Huffines KIA Expansion Site Plan, Parking, & Exception Requests

Presented to McKinney P & Z
December 10, 2024

Huffines KIA Expansion, Site Plan, & Exceptions

SUP2024-0016

South Site Plan Parking Areas

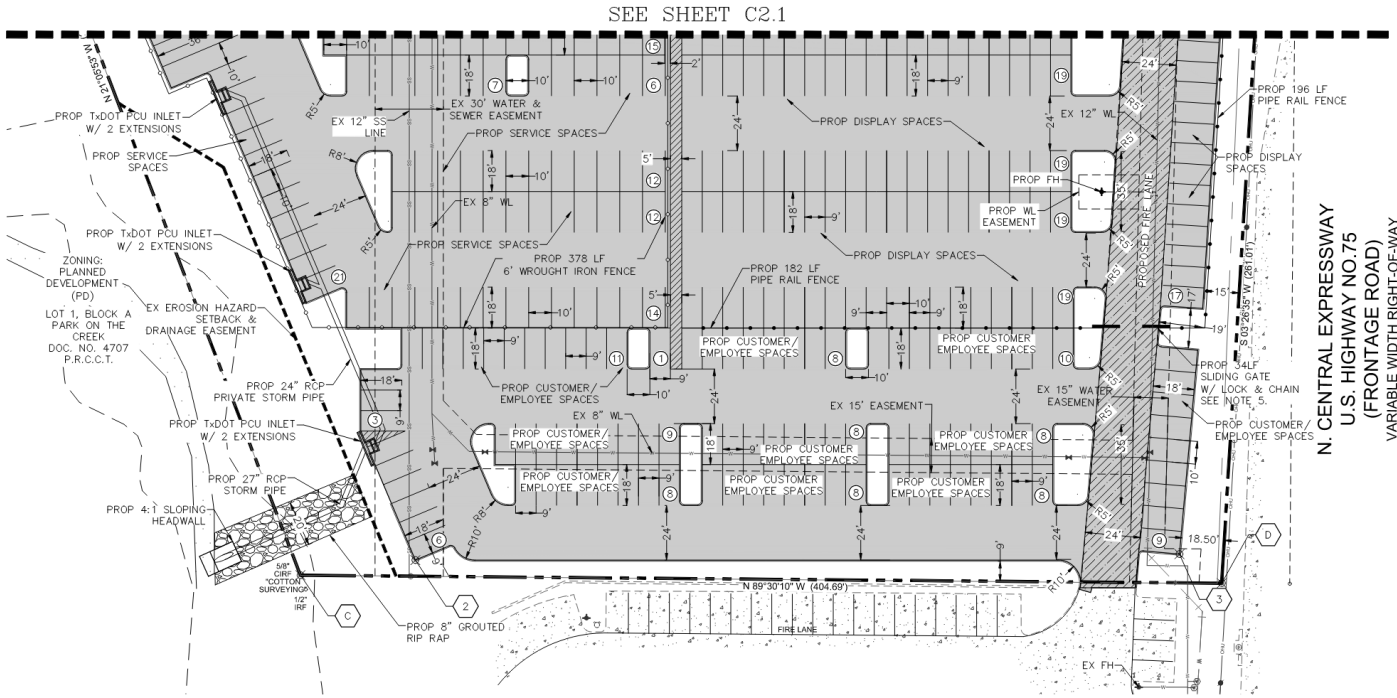
Three parking areas are planned on the parcel immediately south of the KIA sales / service building for required dealership parking including:

- customer cars in for service,
- employee parking, &
- new inventory vehicles
- KIA sales & service expansion required more space for expanded facilities resulting in prior KIA on parcel parking being relocated to the south lot parcel previously planned as a collision center. The collision center will not be built allowing the space required for the 3 KIA operations parking components.
- The 3 Exceptions are explained on next few slides

- Tubular steel or wrought iron fencing is planned between in-for-service cars & new inventory cars; this fence is a necessity for security. The base standard is for masonry columns to be included with the fence. However, we believe that the columns will detract from the visual quality as such fencing painted a dark color and thus naturally blend in with the vehicles. The customer vehicles in for service, generally will be late models and thus will look much the same as new or pre-owned vehicles for sale, thus all blending together.

- The original collision center may have needed more screening as such cars are typically wrecked and / or dismantled. There will be virtually no difference in appearance of all on-site vehicles.

- Thus, we strongly believe the visual appearance will be less desirable with masonry columns that will look out of place.
- Approval of Exception A by P & Z is requested to not require the columns.

- An exception is requested to not require landscape screening with the fence addressed in Requested Exception A.
- Firstly, shrubs that will grow to 5' or 6' height will be a security problem blocking the view into the customer in-for-service parking area; the fence is a necessity for security, but the shrub screening would hinder crime prevention and police monitoring thus diminishing security.

- Secondly, the shrubs would require a planting bed. This site is designed for E to W surface drainage like most parking spaces; drainage across the planting bed would continually erode and would be a major maintenance problem. Installing a drainage main in each E to W access drive is undesirable.

- Instead, we propose to plant extra plant materials in alternate locations to provide both alternative screening and enhance the site aesthetics.
- P & Z is requested to approve this landscape screening Exception B.

Landscape
Plan for
KIA &
Parking

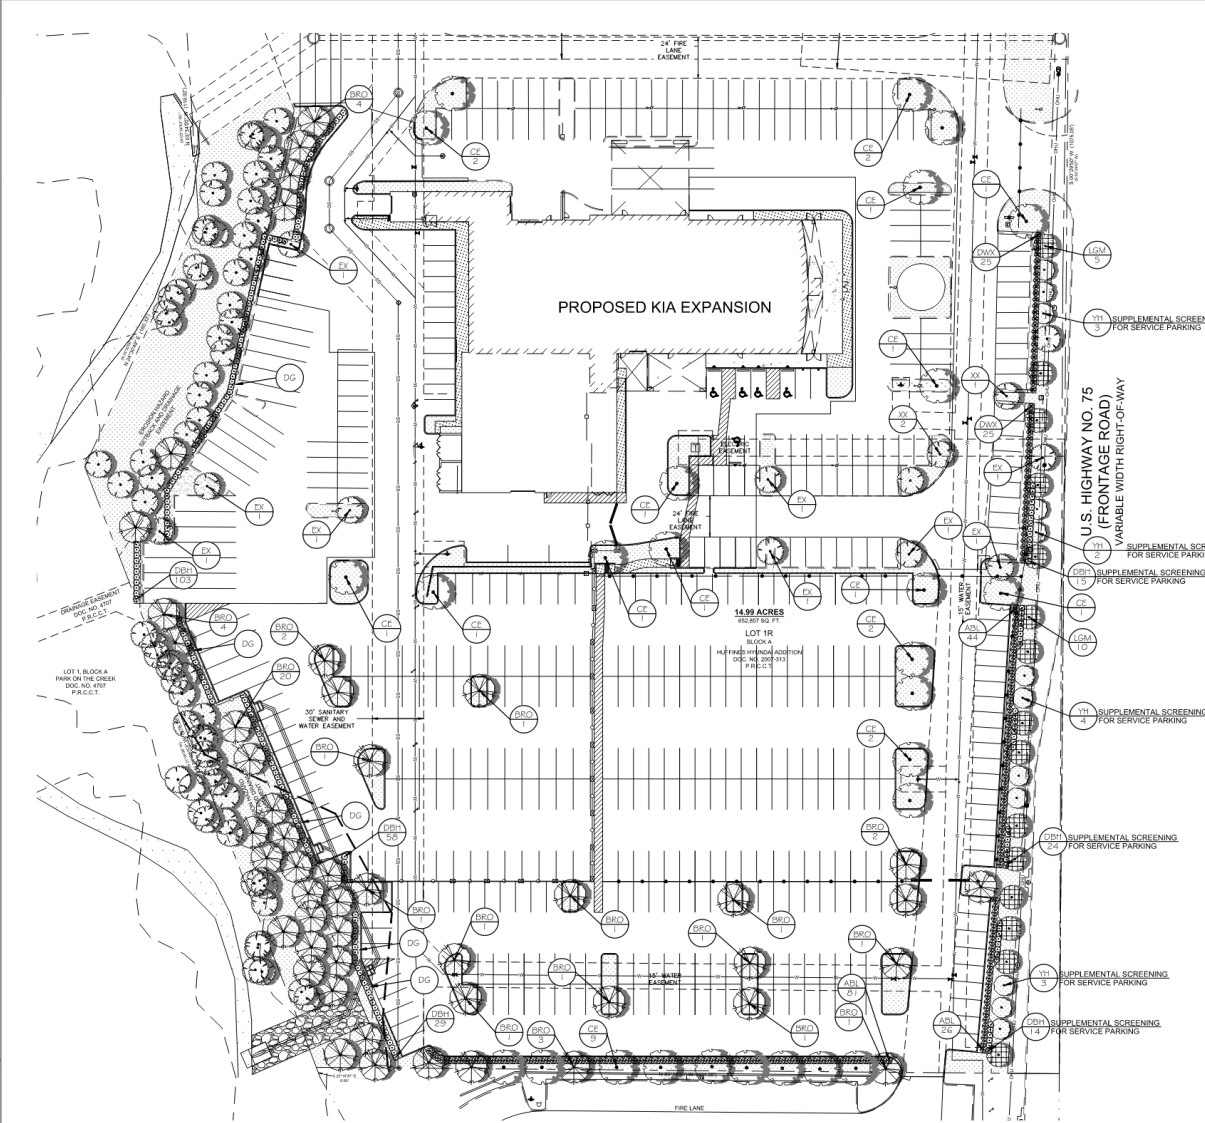
Supplemental Screening for Srv Area:

Required screen shrubs / ord 120 shrubs
Additional shrubs / ord 134 shrubs
Required Screen trees / ord 13 trees
Additional Trees provided 17 trees
